City of Rolling Hills

AGENDA
Regular Planning Meeting

- 8.A. REQUEST FOR SITE PLAN REVIEW FOR GRADING AND TWO WALLS ABOVE THREE FEET; A CONDITIONAL USE PERMIT FOR A DETACHED MIXED-USE STRUCTURE; VARIANCES TO LOCATE THE MIXED-USE STRUCTURE PARTIALLY IN THE FRONT YARD AREA AND TO ALLOW A WALL ALONG THE DRIVEWAY INTO THE FRONT YARD AND A WALL BEHIND THEÂ PROPOSED MIXED-USE STRUCTURE TO EXCEED FIVE FEET ON A DEVELOPED LOT LOCATED AT 24 CINCHRING ROAD. THE PROJECT HAS BEEN DETERMINED TO BE EXEMPT FROM CALIFORNIA ENVIRONMENTAL QUALITY ACT PURSUANT TO SECTION 15303 (NAKAMURA).

SUBJECT: REQUEST FOR SITE PLAN REVIEW FOR GRADING AND TWO WALLS ABOVE THREE FEET; A CONDITIONAL USE PERMIT FOR A DETACHED MIXED-USE STRUCTURE; VARIANCES TO LOCATE THE MIXED-USE STRUCTURE PARTIALLY IN THE FRONT YARD AREA AND TO ALLOW A WALL ALONG THE DRIVEWAY INTO THE FRONT YARD AND A WALL BEHIND THE PROPOSED MIXED-USE STRUCTURE TO EXCEED FIVE FEET ON A DEVELOPED LOT LOCATED AT 24 CINCHRING ROAD. THE PROJECT HAS BEEN DETERMINED TO BE EXEMPT FROM CALIFORNIA ENVIRONMENTAL QUALITY ACT PURSUANT TO SECTION 15303 (NAKAMURA).

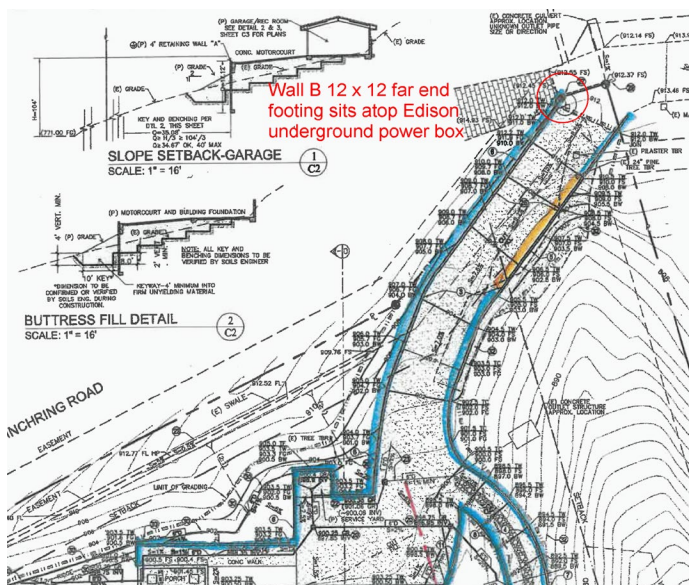
The plans as submitted show, marked in blue on sheet #2, "walls" that can be up to 3 feet in height extending as far as possible, and even beyond the Nakamura property line. This configuration has the potential to impact the entrance into and the exit from both properties of vehicles. As seen on the plans, the far end of wall A is shown reaching beyond the property line into the asphalt area of the double private road leading to both driveways.

Likewise problematic, the required 12" by 12" footing for the far end of wall B will intrude upon the Edison underground power distribution box for both properties.

If these "walls" were to be built to the approved 3 feet height, or even something less, like 2 feet, we feel that the appearance and "traffic" flow to and from the two driveways will be a potential problem. The two driveway entrances meet at an angle of approximately 30 degrees and the proposed "walls" if built to this permitted height would have the effect of funneling cars from both driveways together on a collision course. It would be far wiser for the Planning Commission to specify that "walls" of potentially 3 feet in height in this immediate area instead be curbs 5-6 inches in height.

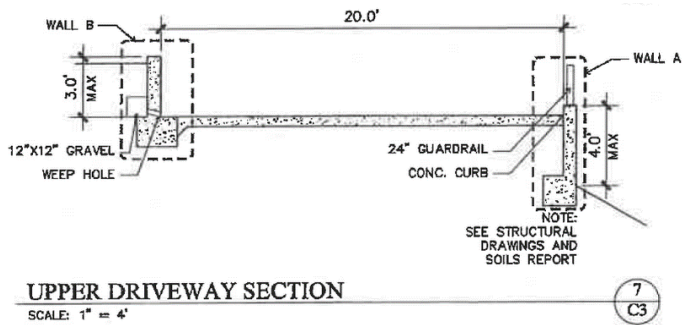
Here is a section through the upper driveway showing Wall B clearly and unnecessarily above grade. Wall A on the far side is said to be a simple guardrail. I fail to see any rational purpose for Wall B. It should match the curb of the opposite side.

Having a 3 foot wall (Wall B) directly abutting our driveway entrance curb would be unsightly, inharmonious, unappealing, and hazardous. The larger utility box to the right is Edison underground. You can try to imagine the appearance of that wall in this photo below of our driveway entrance. The survey stake that you see there is around 3 feet in height.

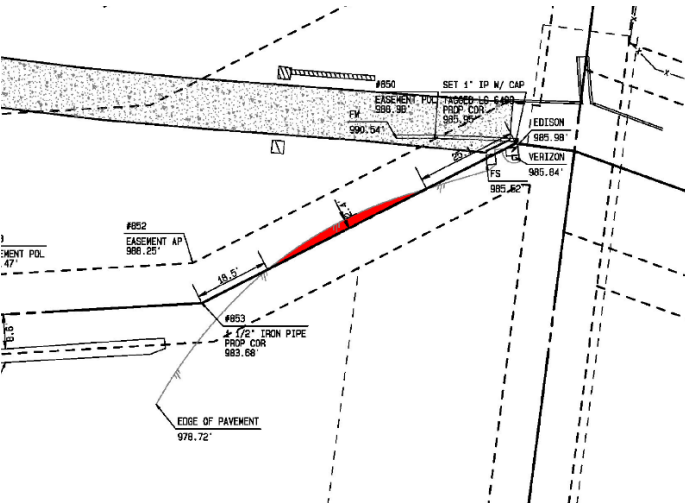
Here is looking down our driveway from the opposite viewpoint.

As you can see there is not really enough room for the footing of the proposed “wall” to be built where the Nakamuras propose without placing it over onto our property. However, much more importantly, the Nakamuras are already intruding upon our property and, in addition, they are suing us for “trespass” and the trimming of the excessive fire-prone acacia bush growth in the easements, which was done in April of 2017. While this lawsuit is pending, in which they question property lines, including those along the proposed driveway, it would be prudent for the Planning Commission to defer the decision regarding Resolution 2021-04 until this legal matter is completely adjudicated.

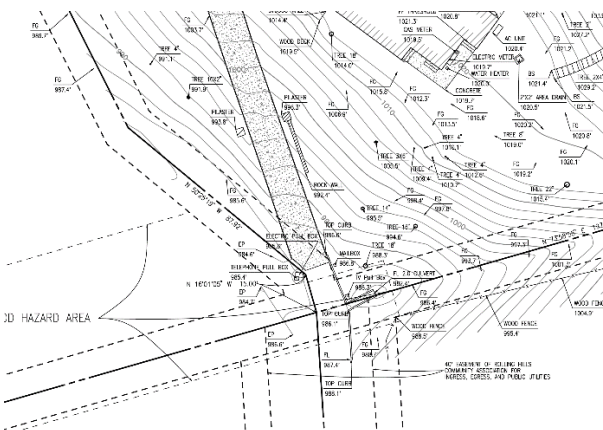
Separately from the above considerations, I question the proposed construction of the accessory unit. I am not a geotechnical expert, but I am the homeowner of a recent Rolling Hills approved extensive remodeling project. I recall the structural engineering that went into the addition of the balconies along the front of our house. Not only were three attractively designed and placed site walls required to bring the grade up so that the balconies would be no more than 3 feet above grade, but there were also more than 50 caissons dug down to bedrock to provide addition structural integrity to the design. This also allowed us to curve the new driveway in towards the house, avoiding the idiotic diagonal cutoff of the old driveway entrance because of the property line, as shown on this pre-construction survey.

I don't see any of that under this accessory building. From our past history with the Nakamuras, they have used family and friends as professionals in the drawing up of plans, etc. This self-dealing nepotism lends itself to abuse that I would caution the Planning Commission to be cognizant of. From their plans, I see a structure that is around 50% built over fill without any other structural reinforcement provided.
